Written submission from Gordon Edwards

Applicability of the Darlington New Nuclear Project environmental assessment and plant parameter envelope to selected reactor technology

Mischief in the Making

The Darlington New Nuclear Project (DNNP)

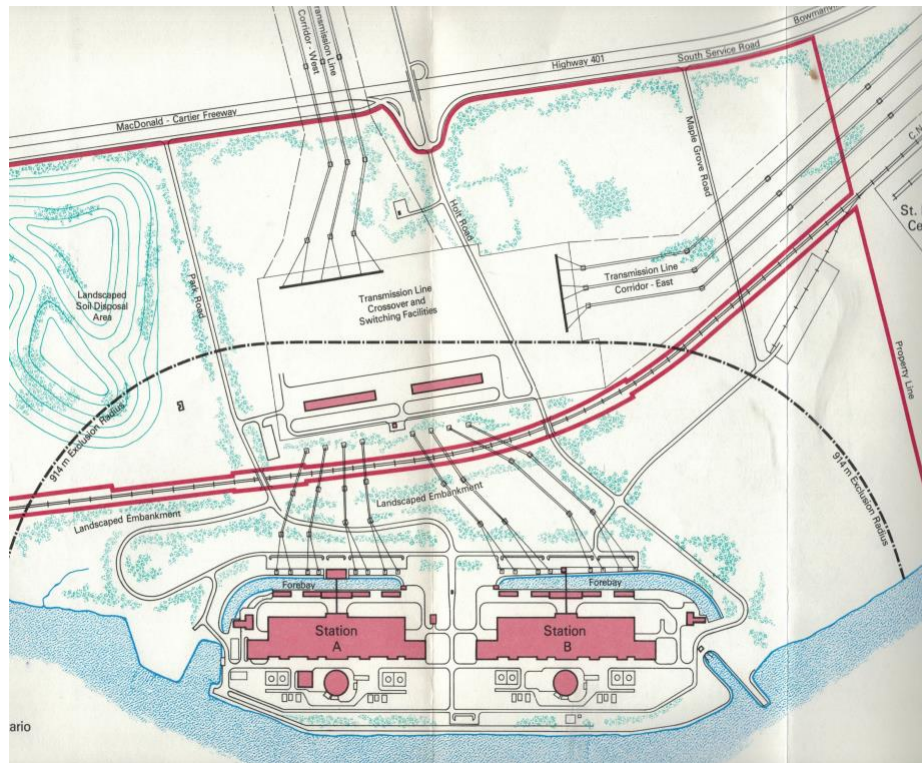
- The BWRX-300 reactor design is unlike any other reactor considered by the JRP in that the entire reactor core together with all of its reactivity control mechanisms are below ground level, in a cylindrical space whose outer walls are submerged in water. [see diagram]

- This cylindrical configuration, which extends 38 metres below ground, containing almost the entire radioactive inventory of the BWRX-300 design, is equivalent to a 10 to 12 storey building where the different floors go deeper and deeper down. Subterranean features related to groundwater, seismicity, and soil characteristics such as potential for liquefaction, as well as the potential impacts from explosive blasts, all require a very different and more nuanced analysis for such a reactor than would be required for an above-ground reactor. The configuration is fundamentally different.
